Investigations into the 800 mm Horizontal Plane Requirement in Regulation No. 44

Transmitted by the expert from CLEPA

39th GRSP Session

CLEPA Proposal – Extending 800 mm plane to 900 mm

Figure 1: Arrangement for testing a forward-facing device.

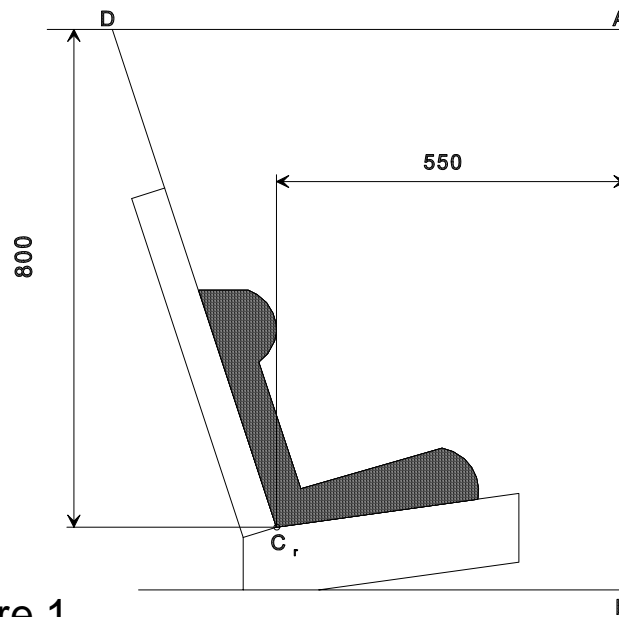
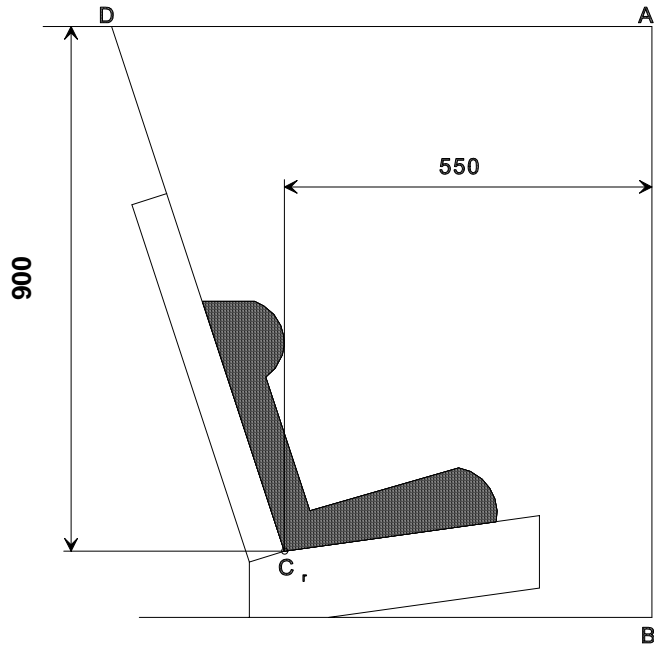
- **PROPOSAL**
- Paragraph 7.1.4.4.1.1., amend to read:
 - "... Figure 1, 800 dimension to read **900**."
- Paragraph 7.1.4.4.1.2.1., amend to read:
 - "...Figure 2, 800 dimension to read **900**."
- Paragraph 7.1.4.4.1.2.2., amend to read:
 - "...Figure 3, 800 dimension to read **900**."
- Paragraph 7.1.4.4.1.2.3., amend to read:
 - "...Figure 4, 800 dimension to read **900**."
